*City of Bristol
Planning Commission*

**REGULAR MEETING - MONDAY, SEPTEMBER 22, 2025
CITY HALL COUNCIL CHAMBERS
111 NORTH MAIN STREET
6:00 P.M.**

CITY OF BRISTOL
SITE PLAN REVIEW COMMITTEE
STAFF COMMENTS - #440

SITE PLAN: "Crown Estates" Site Plan for a multi-family residential development (30 units) at Wolcott Street & Old Wolcott Road; Charlie Talmadge, Applicant. Plans Dated: August 11, 2025 (latest revision); Date of Committee Review: September 3, 2025 (first review)

Elevation Drawings

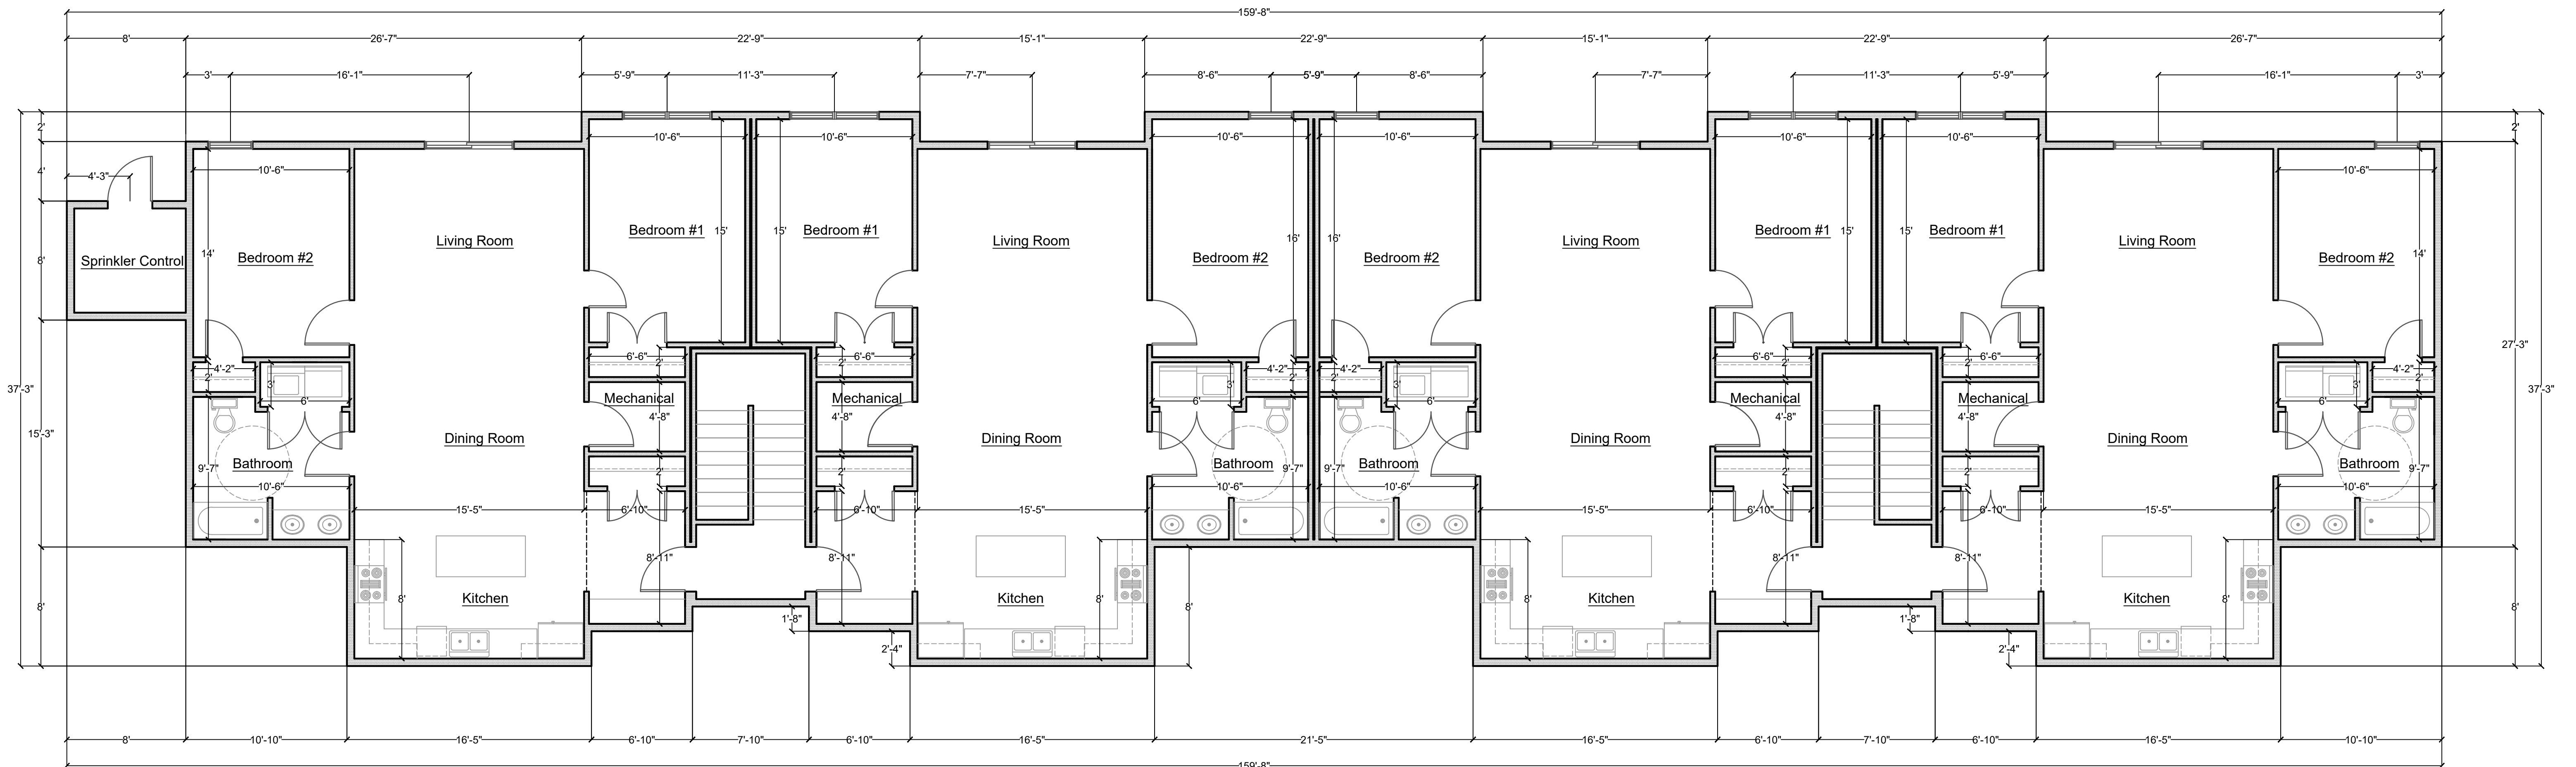
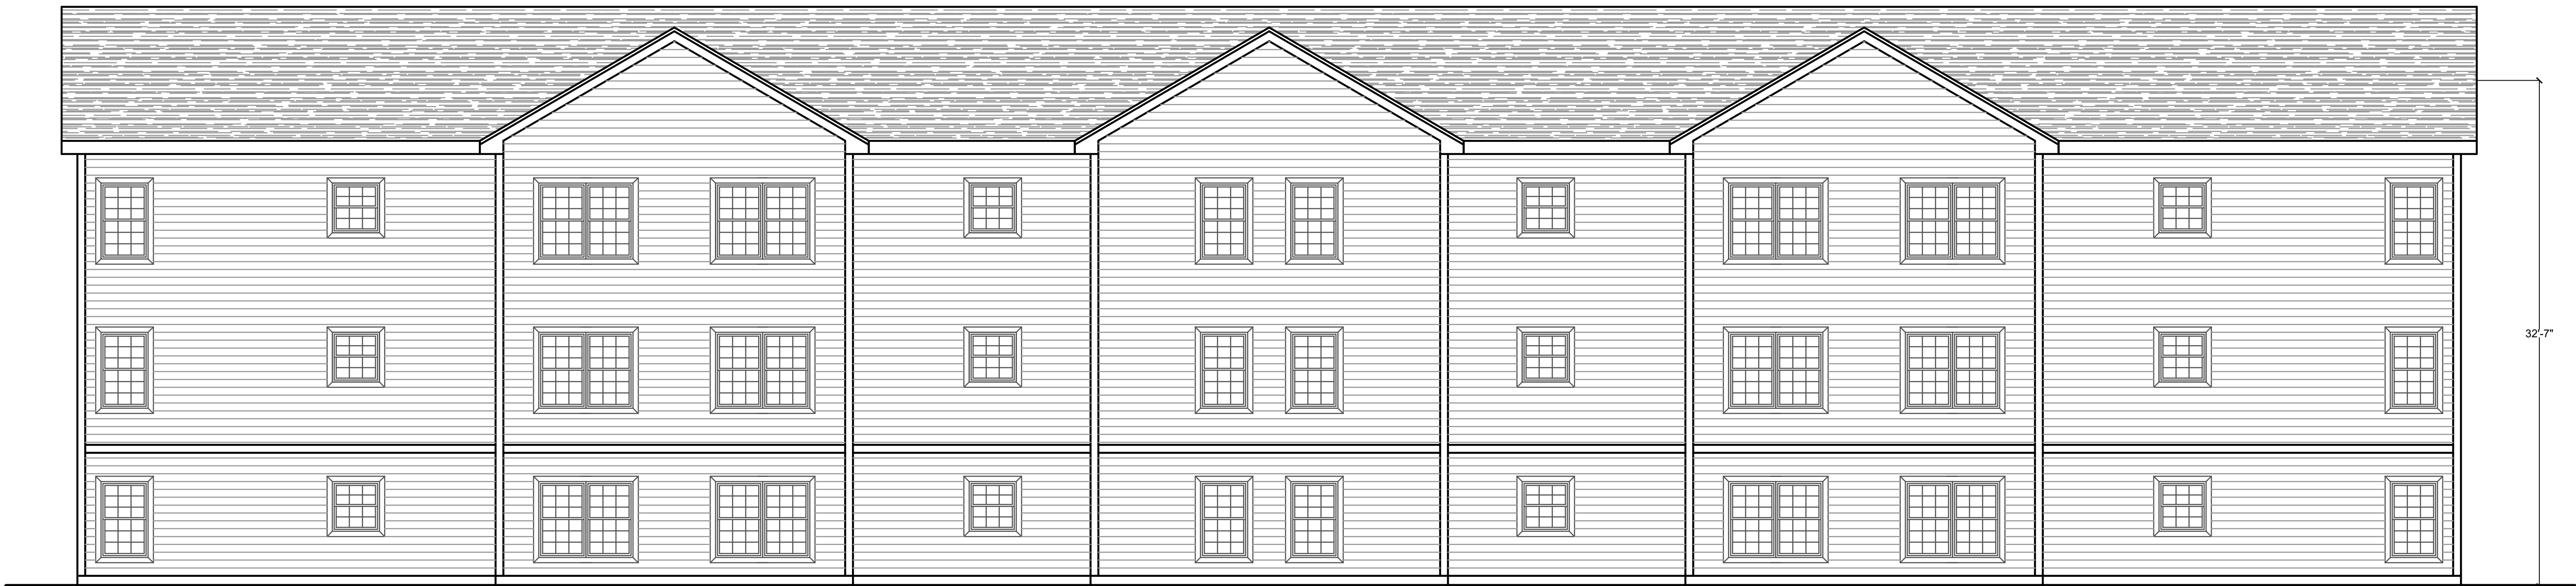
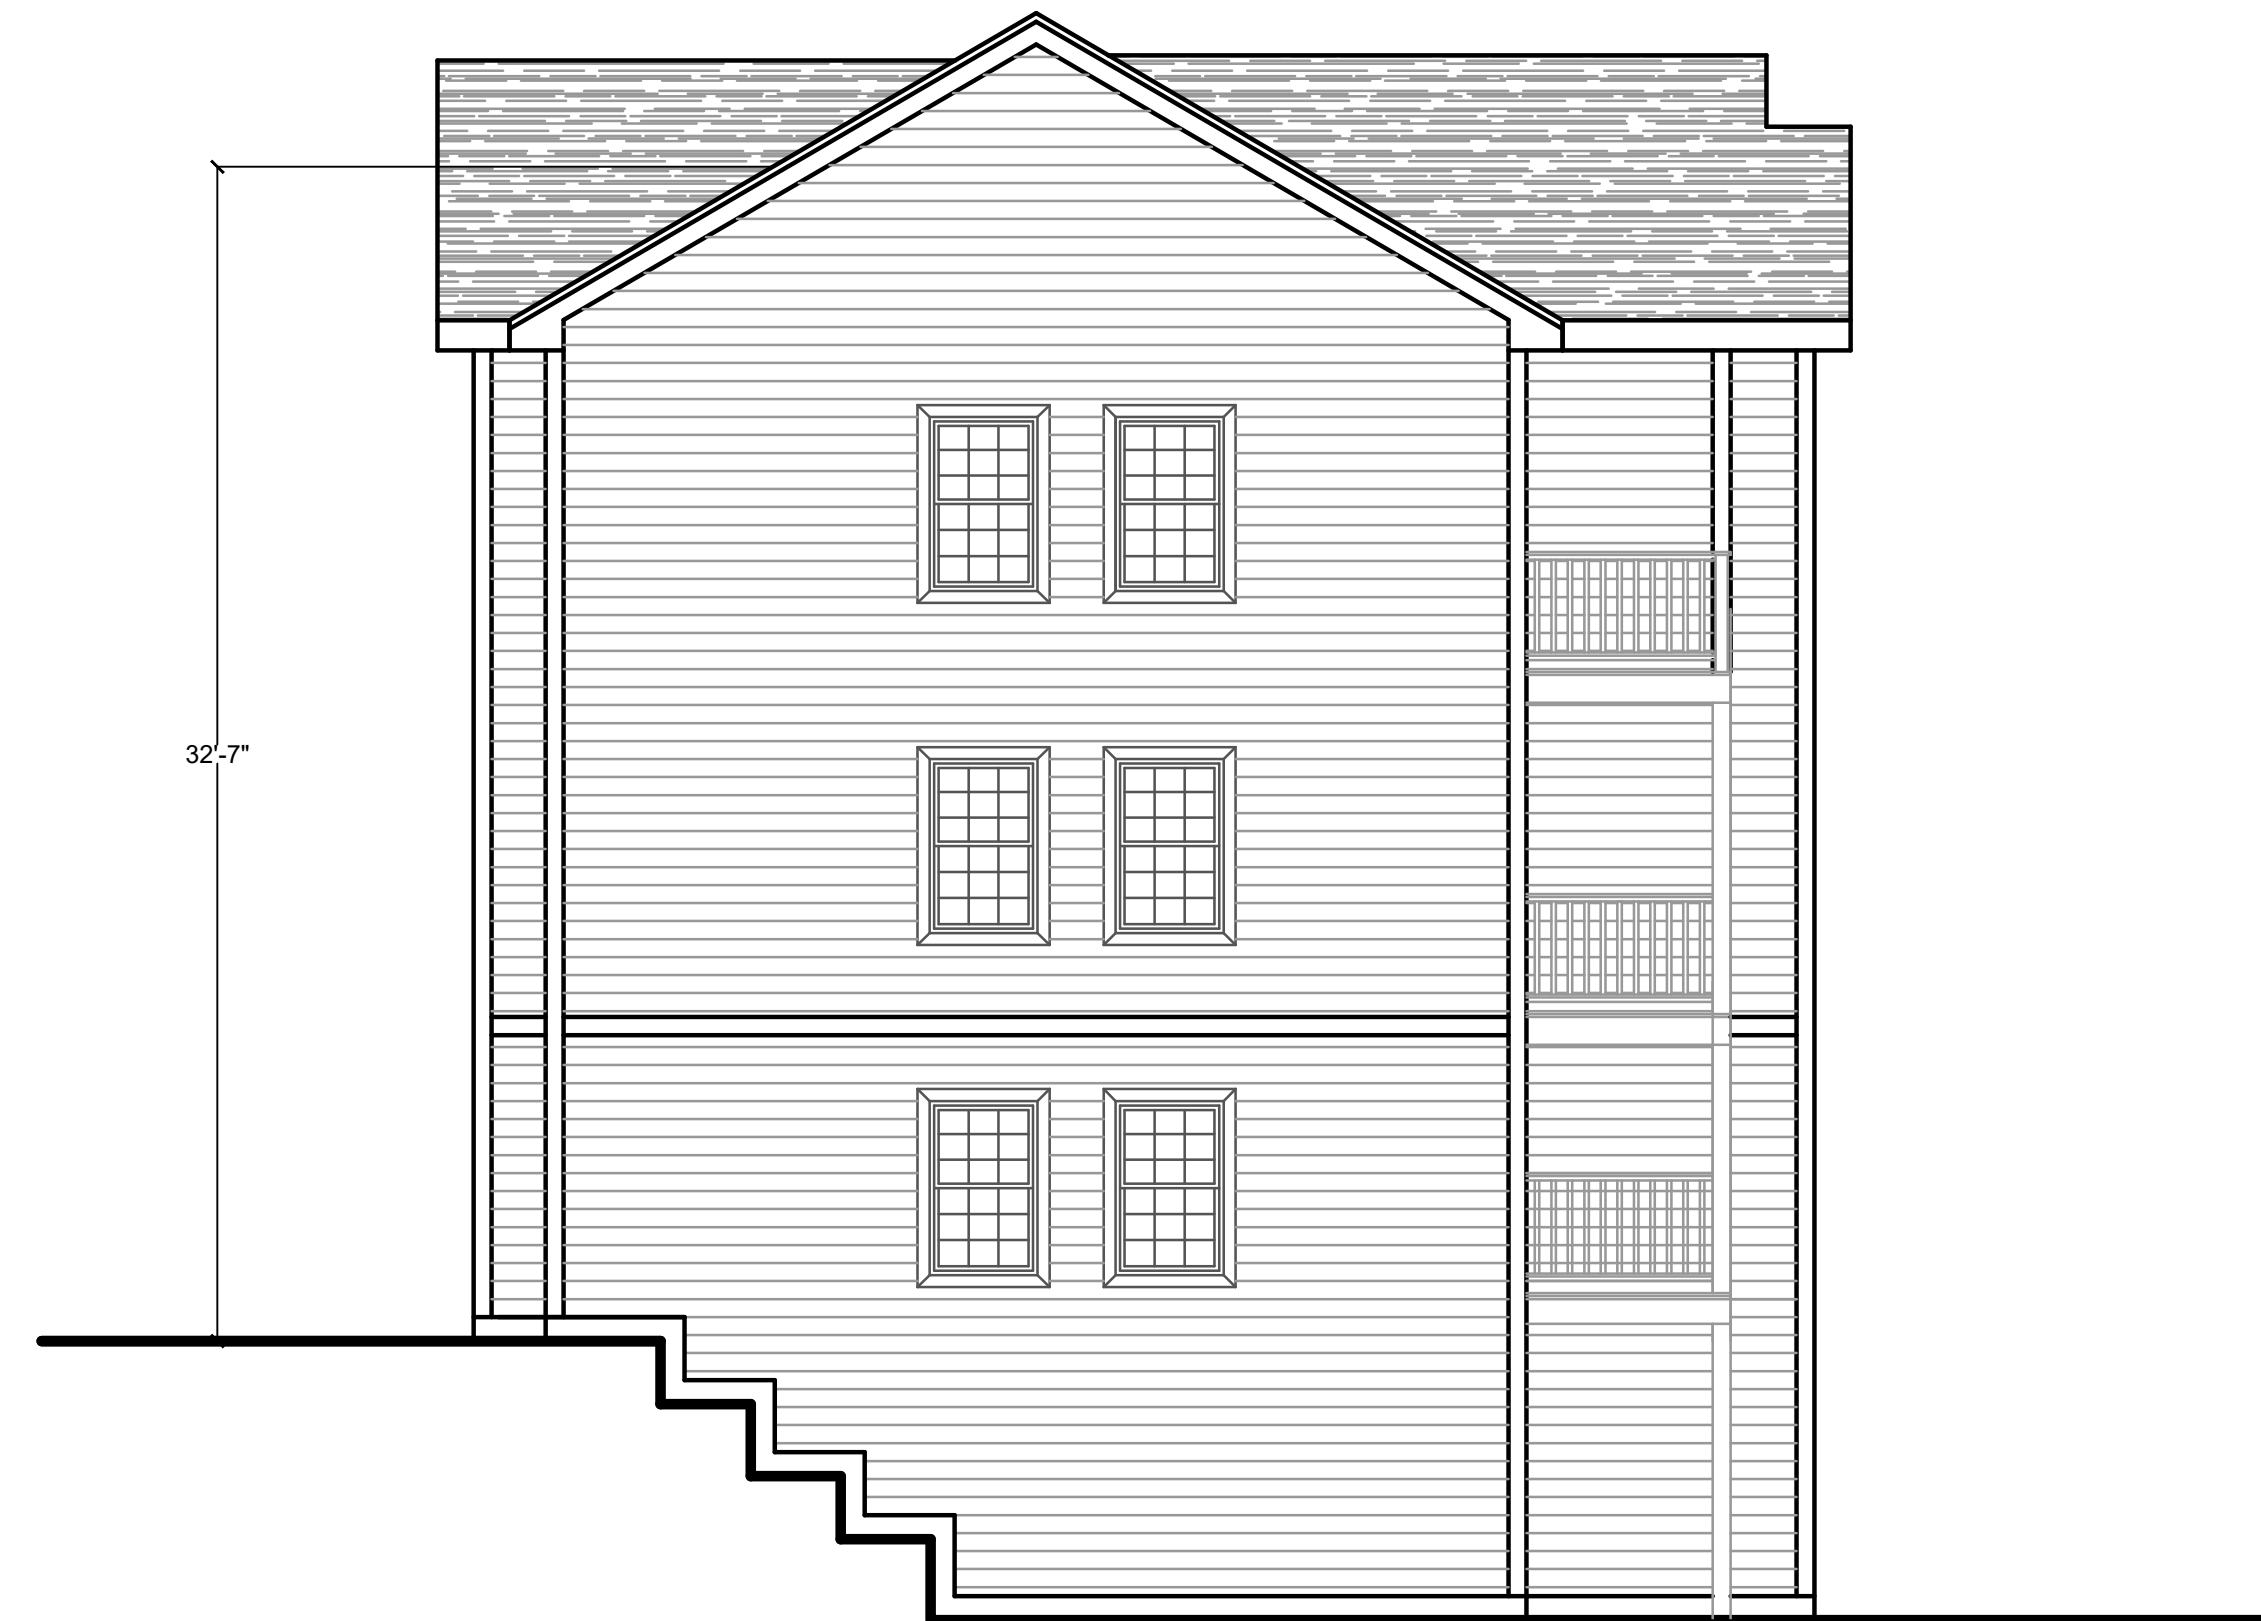
6. Provide parking area landscaping.
7. Will any units near handicap parking be either constructed for or built to accommodate accessibility?
8. The height shown on the elevations of 42 feet and 1 inch exceed the 40-foot height limit in the A-zone. Provide details of the average finished grade or compliance.

16. Does the building have elevators or only stairs?
17. How many bedrooms will the development consist of?
18. Label Building #2 floor plans.
19. Indicate building entries on elevations. Are the main entries shown on the site plan reflected in the elevations?
